Agenda Item 3
821 Northmoor Road
Continued – Revisions to previously approved plans and a building scale variance.

Continued consideration of a request for approval of revisions to previously approved plans for additions and alterations to a residence at 821 Northmoor Road. A building scale variance is requested.

Summary of Request

NORTH ELEVATION AND WEST ELEVATION

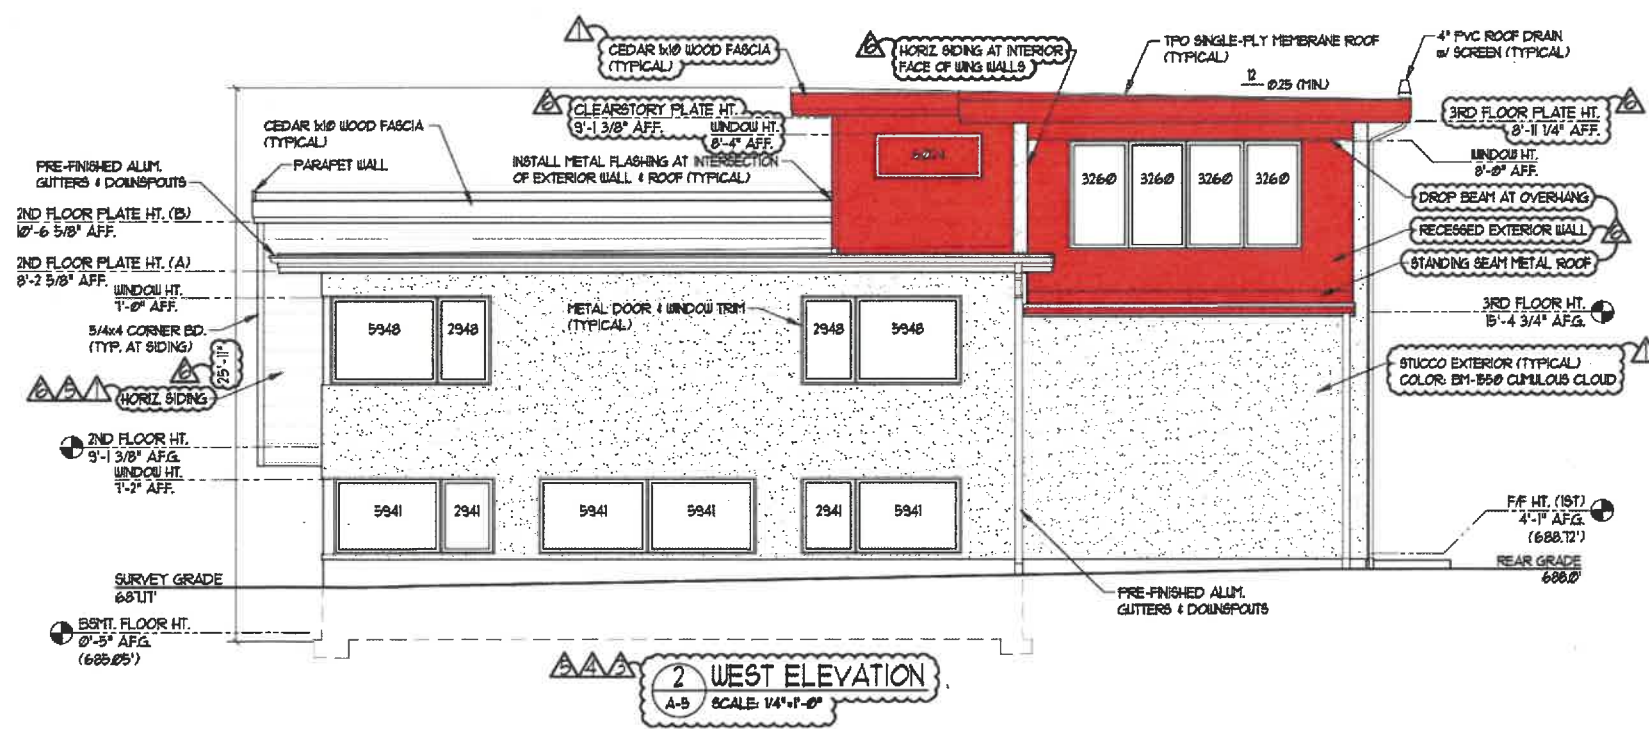
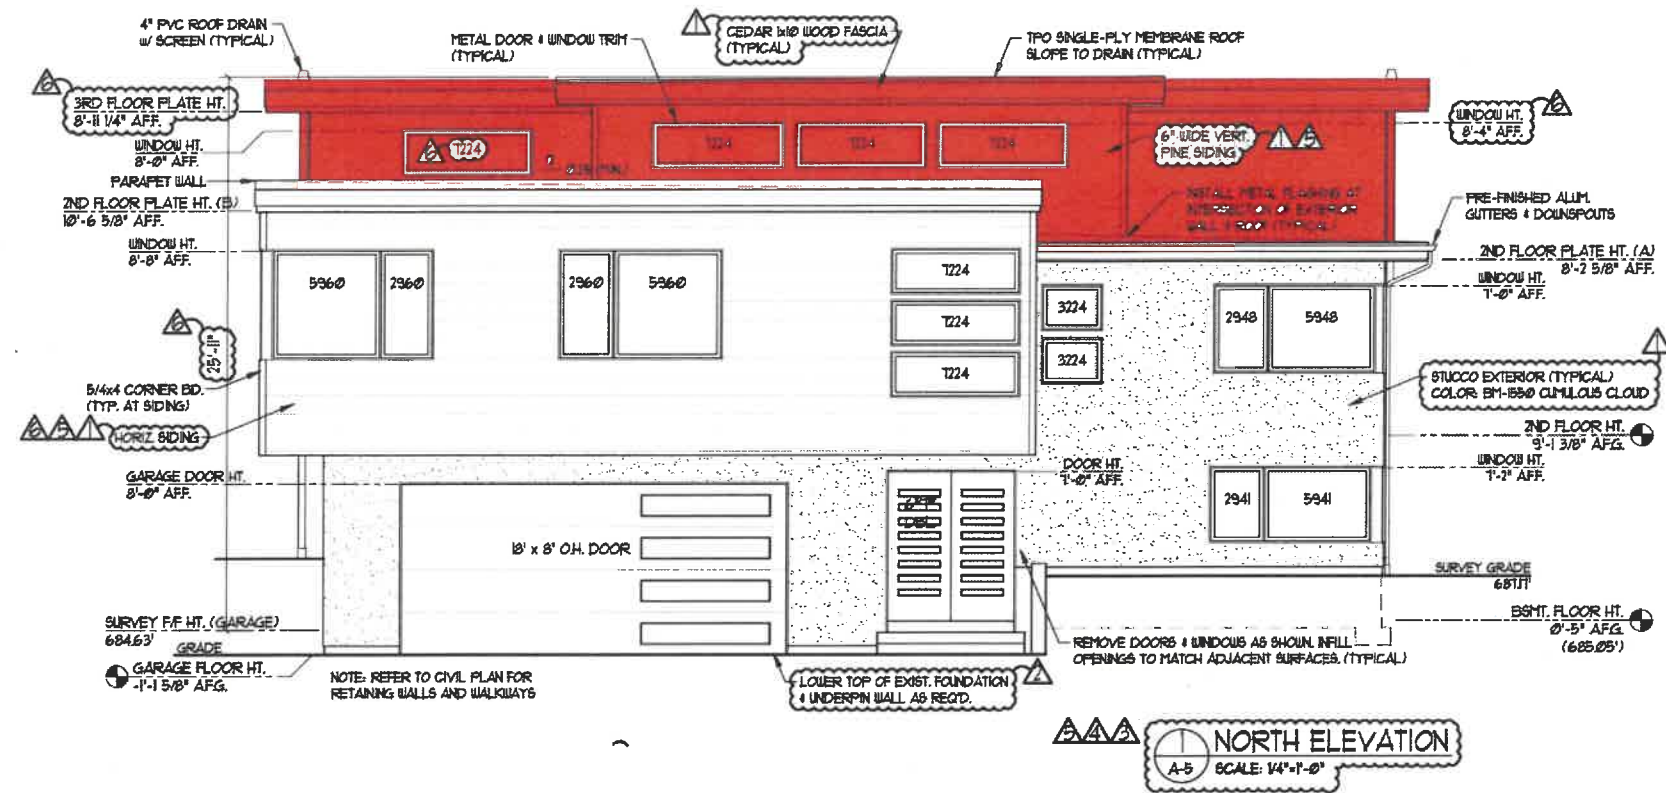
- *Lower the primary suite roof by 12 inches and lower the stairway lantern roof to make it flush with the primary suite roof.*
The primary suite is now lowered by 10 inches and the stairway lantern matches the height of the primary suite.
- *Move the east and west primary suite walls in, eliminating 4 to 5 feet of interior dimension to reduce the square footage and to mitigate impacts on the privacy of the neighboring home to the west.*
The east and west walls of the primary suite are moved in by two feet on each side, eliminating 4 feet of interior dimension, reducing the overall square footage and mitigating the impact of the residence on the neighboring home to the west.
- *Remove the foyer/back hall to reduce the square footage.*
The foyer/back hall, addressed as the “mudroom” by the petitioner in the statement of intent, is removed from the plans.

In response to comments and direction of the Board, the massing and height of the residence was reduced by removing the stairway lantern, lowering the primary suite roof, bringing in the primary suite walls, and removing the first-floor mud room.

LANDSCAPE PLAN

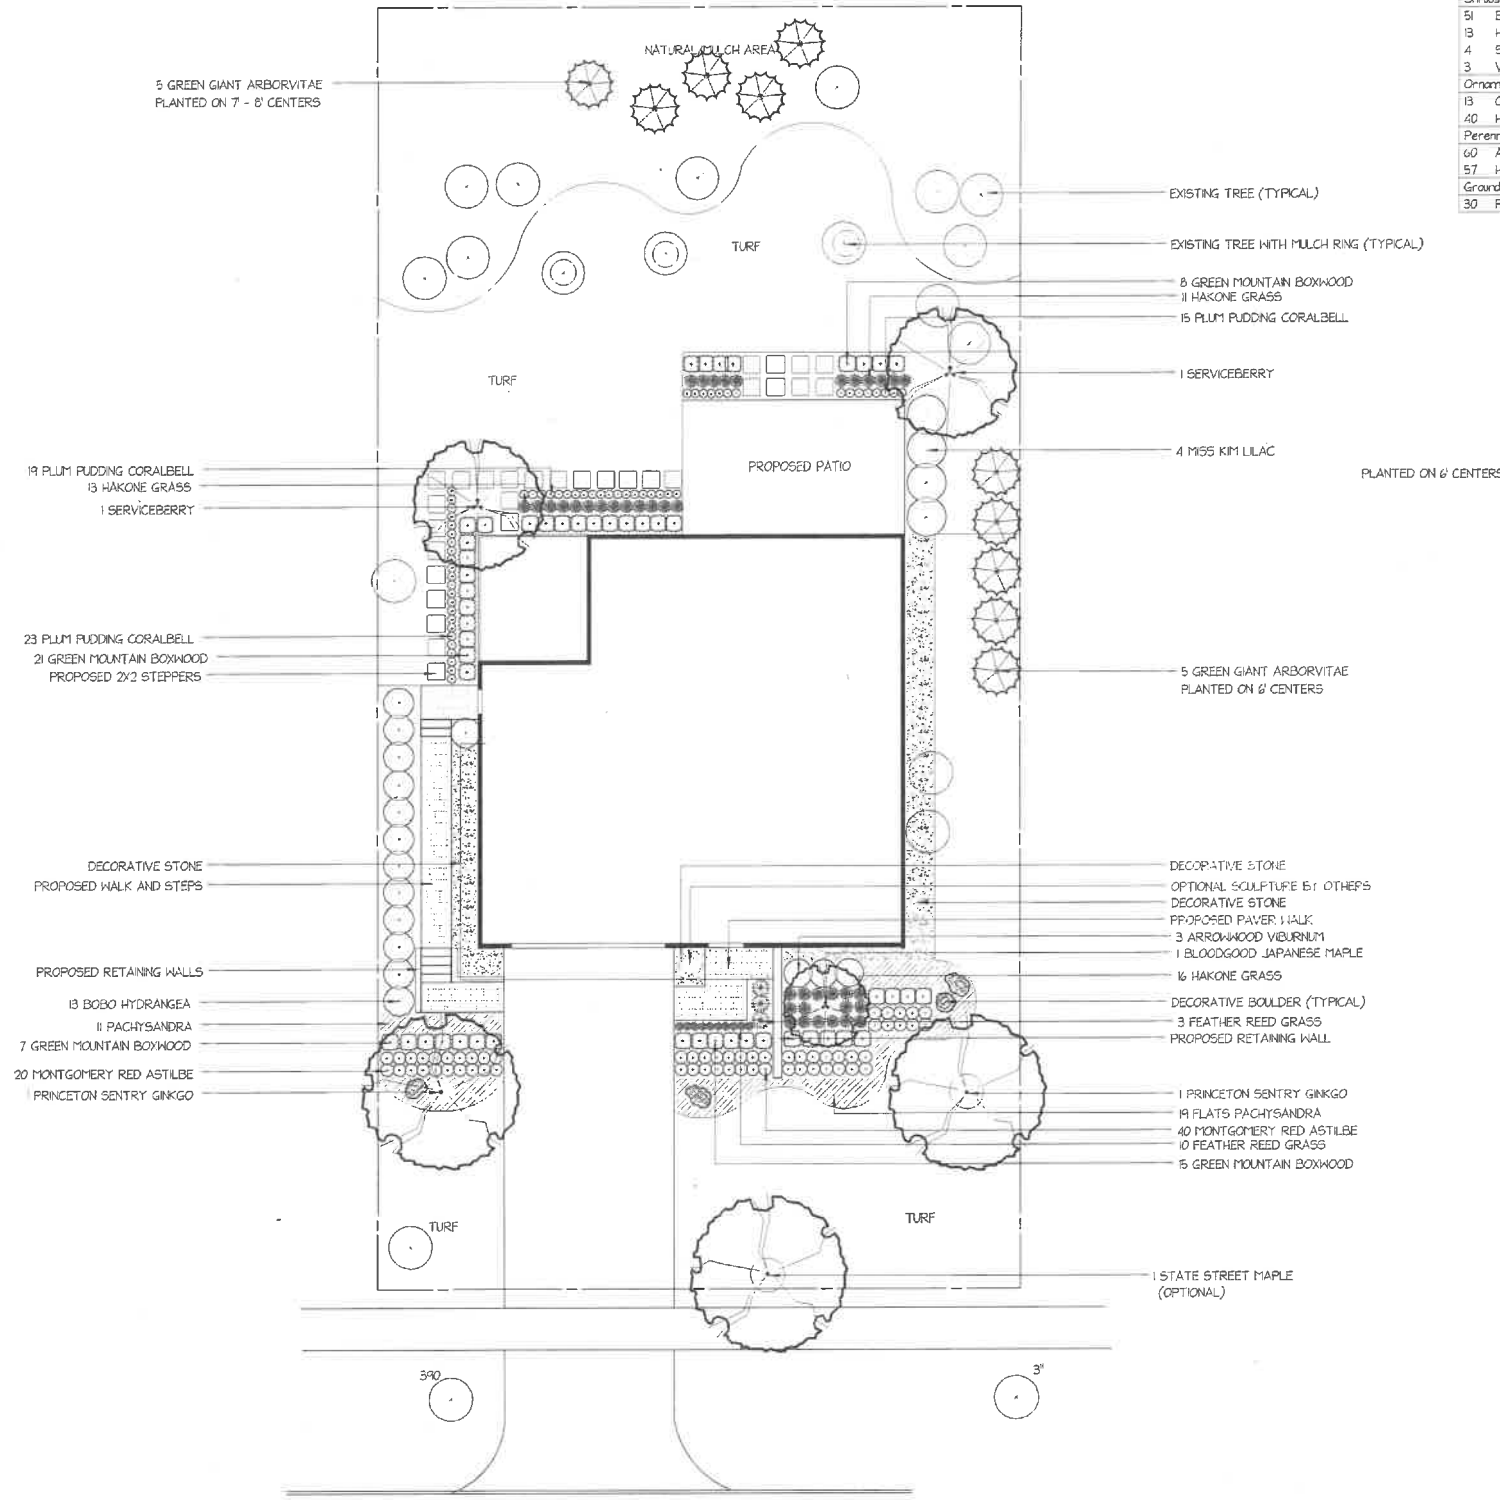
This standard is generally met. The landscape plan reflects arborvitae along the south and west property lines in an effort to mitigate the impacts of the mass of the structure and potential light impacts on the neighboring properties.

To mitigate the visual impact of the structure on the adjacent south and west properties, the petitioner proposes arborvitaes. The petitioner has stated a willingness to work with City staff and neighboring property owners to review and get feedback on the proposed landscape plan. The final landscape plan will be reviewed by City staff and shared with adjacent property owners.

1. All modifications to the plans including those detailed above and any others made in response to Board direction or as the result of final design development, shall be clearly called out on the plans submitted for permit. Staff is directed to review any changes, in consultation with the Chairman as appropriate, to determine whether the modifications are in conformance with the Board's direction and approval prior to the issuance of any permits.
2. Prior to the issuance of a building permit:
 - Landscape Plan*
 - a. Prior to submitting for permit, a detailed landscape plan shall be provided to the immediate neighbors to provide an opportunity for review and input.
 - b. Prior to planting, specific locations of plant material shall be stake on the site and subject to City staff review and approval.
 - c. The arborvitae shall be a minimum of six feet tall at the time of planting.

We have updated our landscaping plan to include five Arborvitae along both the south and west property lines. We will work collaboratively with adjacent property owners during installation, allowing trees to be dry-set to ensure optimal placement and privacy screening. Existing mature trees are also present, but we acknowledge the need to supplement lower coverage due to tall trunks. We will consult with the City Forester on species selection and placement. Any changes to the landscaping plan will be submitted administratively if they fall outside the original scope of approval.

DRAWING LIST
 PROPOSED SOUTH ELEVATION
 PROPOSED EAST ELEVATION
 2nd FLOOR ADDITION & INTERIOR REMODELING
 980 MELLODY RD LAKE FOREST, IL

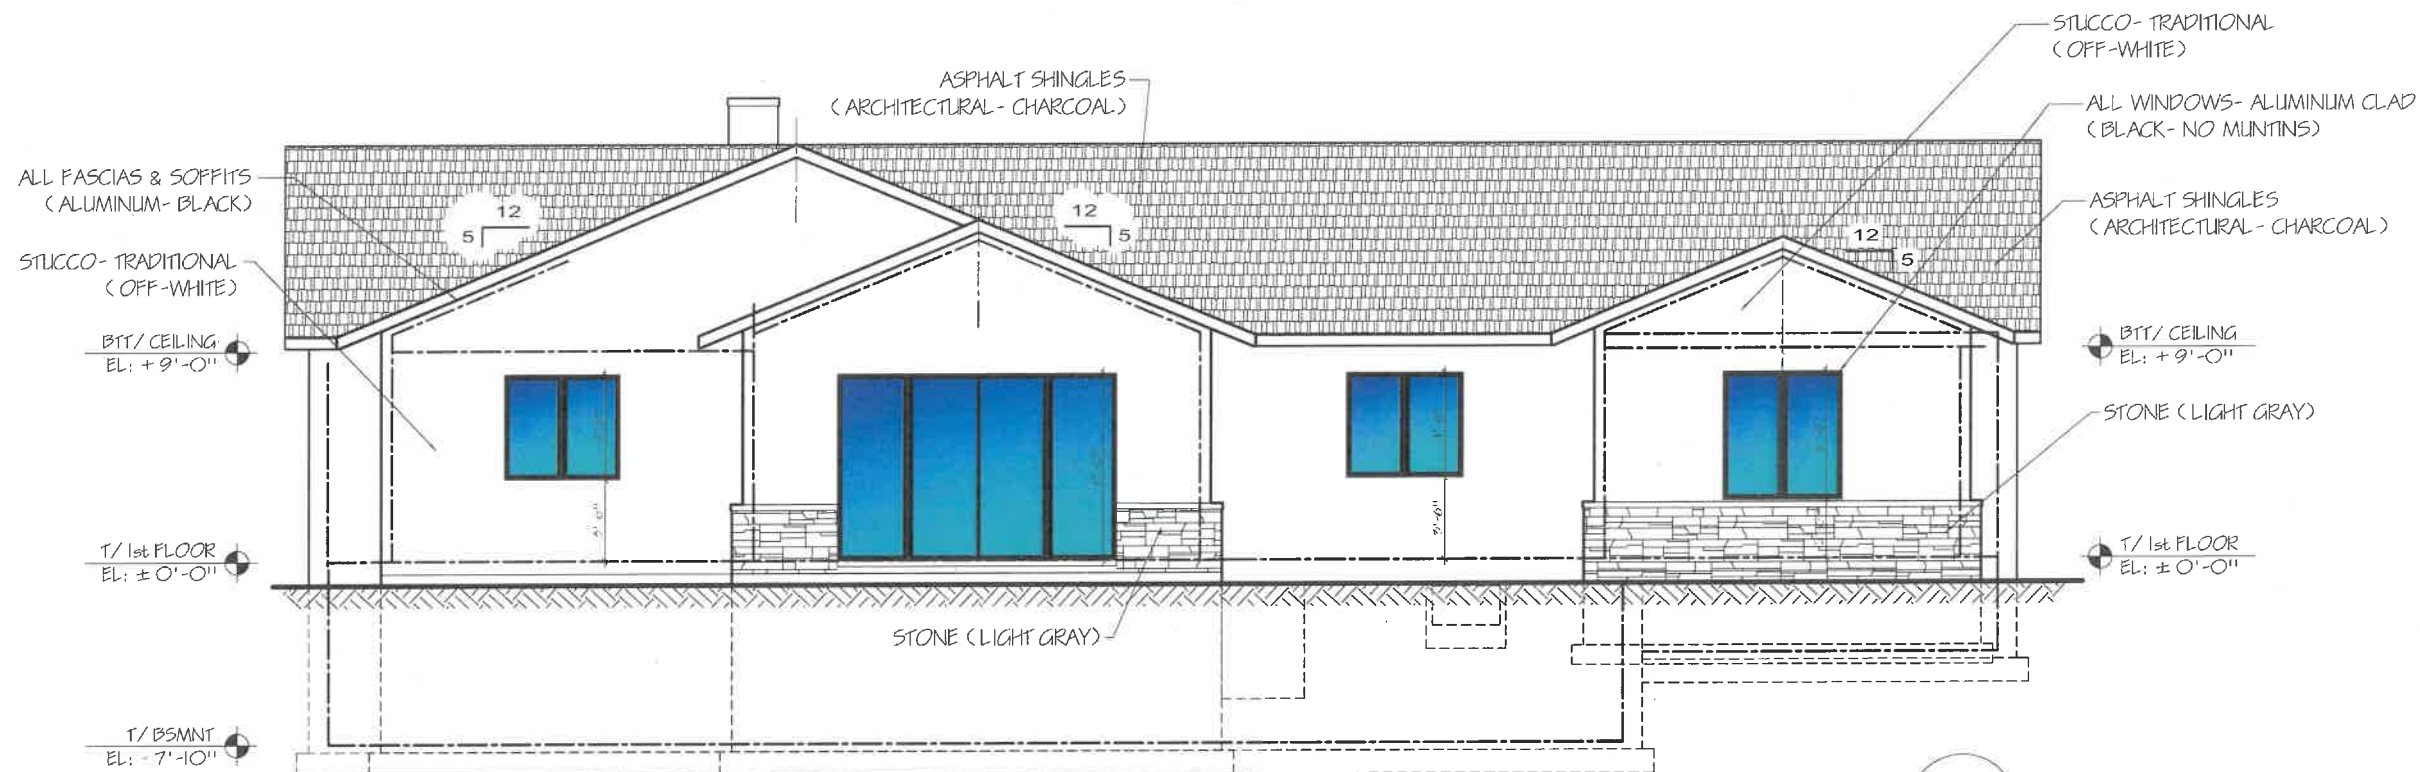
- a. Refine all elevations to achieve a more regular pattern and proportional arrangement of windows and solid walls to more closely align with the City's Residential Design Guidelines.
 - Add two windows to the mudroom to align with the windows on the garage.
 - Add a window in the closet on the rear elevation.
 - Use a double window in the breakfast room.
 - Improve the proportions of the windows on the side elevations.

In response to comments from the Board, the petitioner is making significant changes to the design originally proposed. The house is now one story, the elevations appear less stark and the pattern and proportional arrangement of windows and solid walls more closely aligns with the City's Residential Design Guidelines. Further attention should be given to the proportions of the openings to solid walls on the east and west elevations. Overall, the changes better maintain the character of the original ranch style home and the product fits more quietly into the neighborhood than the design previously proposed.

As recommended, we have eliminated the second story addition and are retaining a one-story ranch layout. This will reduce the challenges related to the massing of the wings and the center of the house. Many of the exterior design concerns, such as the cantilevered extension on the north elevation, the two-story entryway tower, and the placement of the dormers relative to the windows have naturally resolved with this change. Our modified design has windows that are more symmetrically placed on the façade.

We have retained a gabled wall dormer over the west wing of the home on the south elevation to provide architectural interest and balance with the gabled wall dormers on the rear of the home. The slope and design is consistent with other ranch homes in the area. The roofline has been raised to prevent low ceilings in the front bedrooms and an abnormally low garage entrance. To retain the midcentury feel, the fascia flows in a connected manner around the home. We retain the existing stone facade, although it will be lowered to window height, and extended to the rear of the home; mixing in stone that is as consistent as possible to retain a uniform look.
